PLATEAU MINING COMPANY

Enclosed is the balance of the information you requested in your October 7th letter.

RE: Approval of Solid Waste
Disposal Site at WATTIS Mine

Triangular Diversion Cross Section

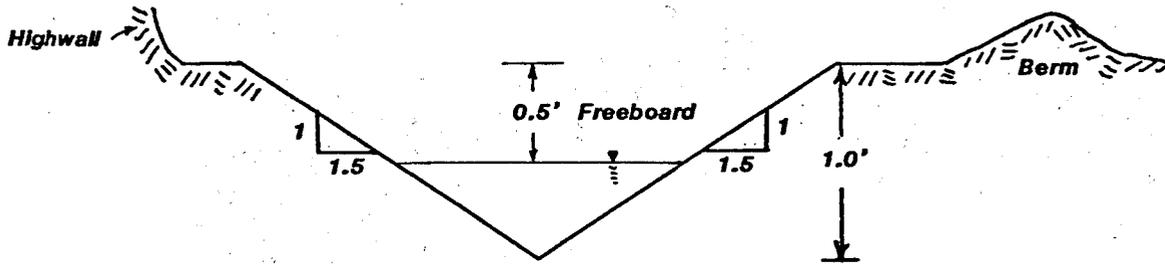
Also, as per your request, included herein is the design of the undisturbed area by-pass ditch located at the base of the highwall on the pad containing the Lion Deck refuse bin. The design flow for the ditch is the same as that indicated above for Culvert No. 1. As indicated by Steve Rigby of your office, the design slope for the ditch is to be 1.0 percent. The minimum ditch design is illustrated on the following page.

At a design flow of 0.53 cfs, a design slope of 1.0 percent, and the triangular cross section illustrated above; the velocity will equal 1.7 feet per second. Therefore, erosion control measures for the channel should not be needed.
